**SERVICE BULLETIN**

TF03-001

**TRANSFER CASE OIL LEAK**

**APPLIED VEHICLE:** 2001-03 Pathfinder (R50) – "LE" Model ONLY (with "All-Mode", "TX-14" Transfer Case)

Figure 1 (top view with transfer case out of vehicle)

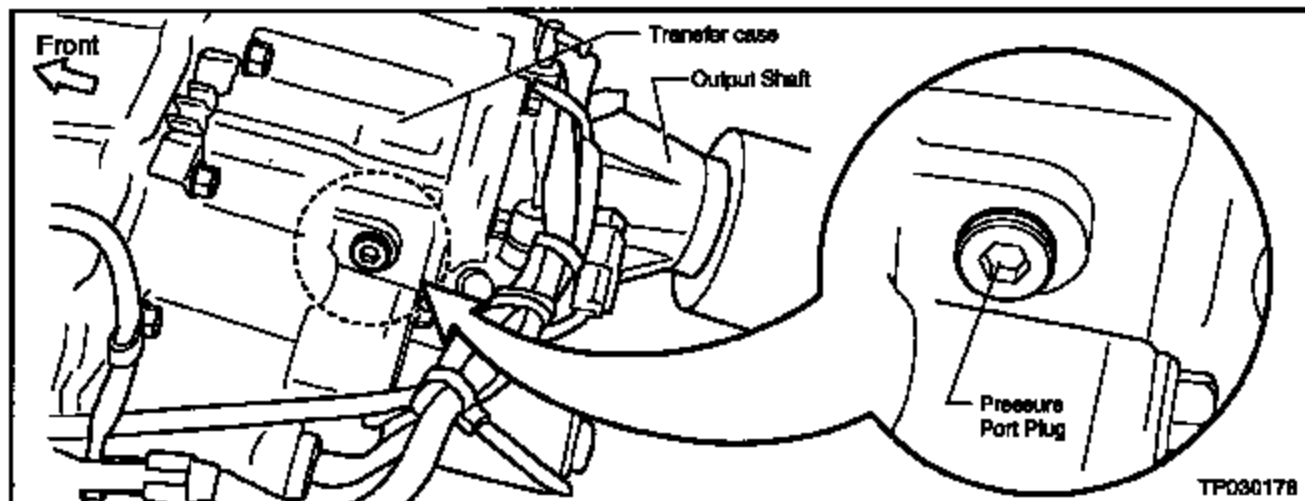
An applied vehicle has an oil leak coming from the Pressure Port Plug on the transfer case (see Figure 1 below).

- Remove the transfer case. Refer to the removal and installation procedures in the applicable Service Manual.
- Remove the old Pressure Port Plug, clean up the hole and surrounding area, then install the NEW Pressure Port Plug (P/N 31306-2W510).

**NOTE:** The new Pressure Port Plug is self-sealing.
